B&W FUEL COMPANY

March 9, 1993

REFERENCE: Certificate of Compliance for Model No. 51032-2, Docket 71-9252

ATTACHMENT I

Figure 1 - Strongback Channel

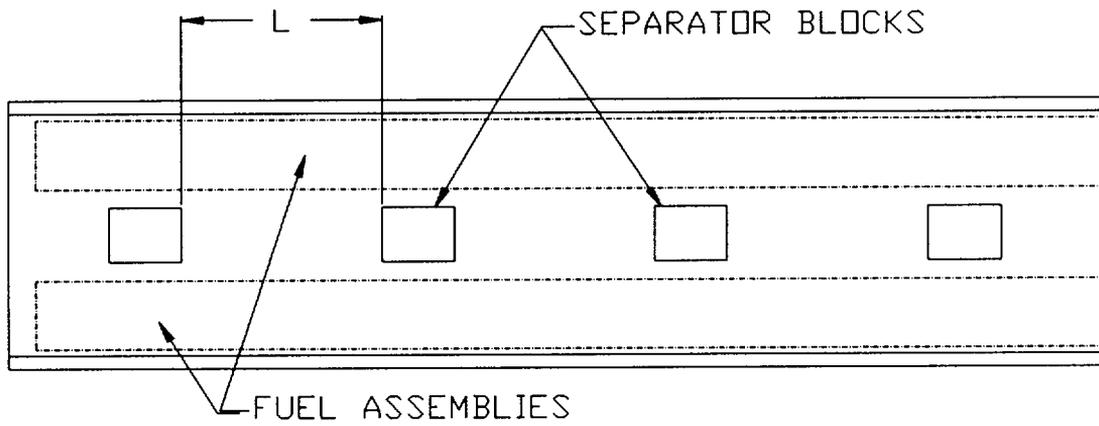
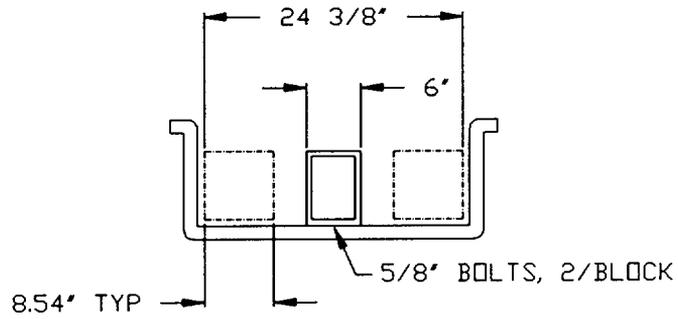
3. Evaluate the separation distance between fuel assemblies during the 30-foot side drop test. Note that criticality calculations should be based on the minimum separation between fuel assemblies.

Fuel assembly-to-separator block spacing (See Figure 1), prior to drop, assuming the fuel assembly outer envelope is 8.54 in. for MK-B, can be calculated as follows,

Combustion Engineering later gave consideration to the potential for rod bow in the open spaces between the separator blocks after a horizontal side drop. BWFC also evaluated the amount of rod bow that could occur for the BWFC Model 51032-2 cask as a function of separator block spacing. The BWFC Model 51032-2 shipping cask will maintain a separator block spacing that will not exceed 11.4 inches in order that rod bow will be maintained less than 0.648 inches during a horizontal drop accident.

With fuel assemblies assuming a normal configuration within the shipping cask, a 0.648 inch gap is maintained between the separator block and the edge of the fuel assembly to facilitate loading and unloading of the assemblies. This spacing is maintained for the bottom fuel assembly during a horizontal side drop as long as the two 5/8 inch grade 8 carbon steel bolts holding the separator blocks to the strongback or the blocks themselves do not shear or deform during an accident. BWFC performed a structural analysis, provided as Attachment 1A, on the separator blocks assuming the top assembly came loose from

the clamps and impacted the separator blocks. The results of this analysis demonstrated that the separator blocks would remain in their original positions during a horizontal side drop accident if two 1 inch diameter bolts were used to secure the separator blocks. Additionally, a gusset plate was added to the separator blocks to prevent deformation. The rod bow in the top fuel assembly caused by the horizontal side drop accident is offset by the gap between the separator blocks and the bottom fuel assembly as long as the longitudinal distance between separator blocks does not exceed 11.4 inches. Therefore, the minimum 6 inch separation between assemblies in a cask, which was assumed for both normal and accident calculations is conservative for criticality calculations.

$$6 + 0.648 - 4.18 \approx 2.5 \text{ in.} \ll 6 \text{ in. required}$$

$$\therefore L = ((0.648)(2)(29)/(0.288))^{1/2} \approx \underline{11.4 \text{ in.}}$$

Figure 2 - Separator Block ANSYS Model

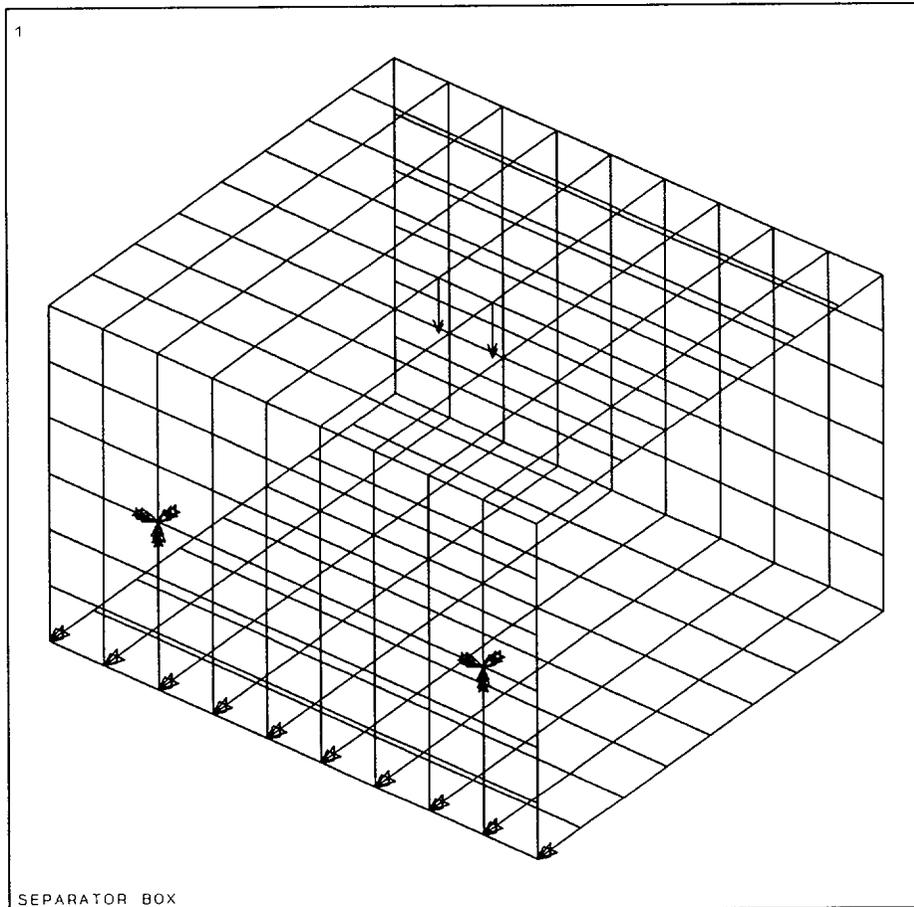
A finite element model of the separator block using "shell" elements (STIF 63) was made on ANSYS 4.4A(Ref. 10) to estimate the block stiffness. Loads ranging from 2,000 to 100,000 pounds were applied at the center of one side of the block(nodes 105 & 106), while two points in the approximate location of the bolts were constrained in 6 degrees-of-freedom and the nodes along bottom edge of the block were constrained in the Z-direction to simulate the constraint of the strongback that the block is bolted to(See Figure 2). The actual impact load of the F/A onto the separator block would be more distributed, therefore this is considered conservative.

**Figure 3 -
Separator Block - Load vs. Deflection(ANSYS)**

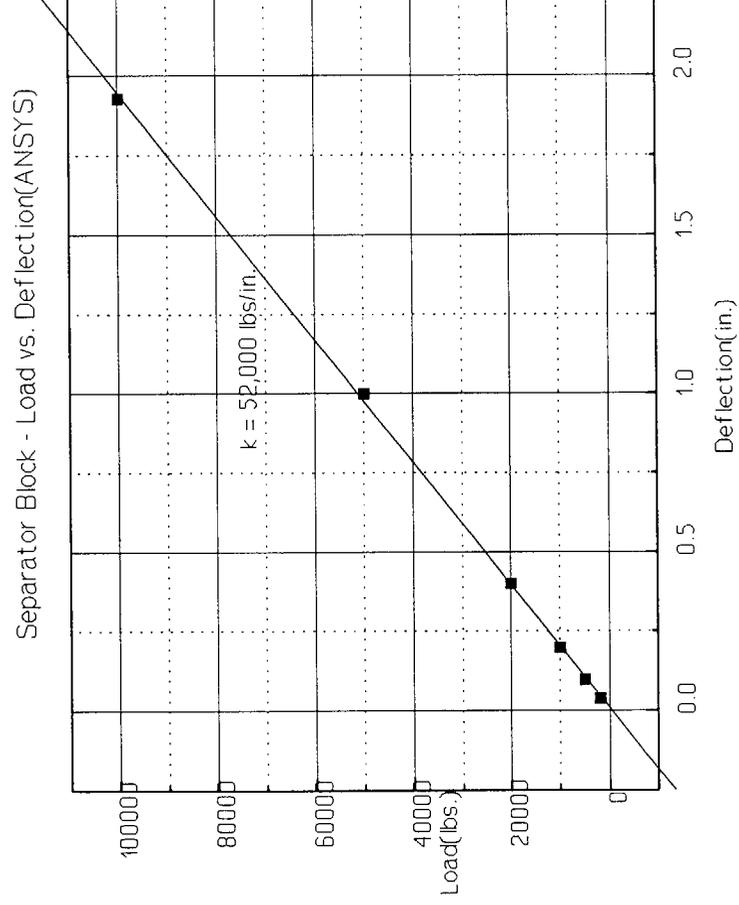
The results can be seen in Figure 3 in terms of an apparent linear "Load vs. Deflection", from which the approximate stiffness of the separator block, in its actual orientation, is determined. It should be noted that in this section it is assumed that the strongback and F/A are rigid and do not deflect or absorb energy upon impact. All energy is thus absorbed by the separator block and bolts, where the stiffness of the block is the limiting case. This is also conservative. The calculated stiffness of the block is 52,000 lbs/in. An unrestrained deflection, "x", is then determined for the above stiffness by equating kinetic energy and "elastic" potential energy as follows,

$$F = kx = (52,000)(1.59) = 82,680 \text{ lbs.}$$

$$\tau = 82,680/0.614 = 134,747 \text{ psi. } \gg 78,000 \text{ psi.}$$

$$d_{\text{min}} = ((2)(82,680)/(\pi)(78,000))^{1/2} = 0.821 \text{ in. } \rightarrow 7/8''$$
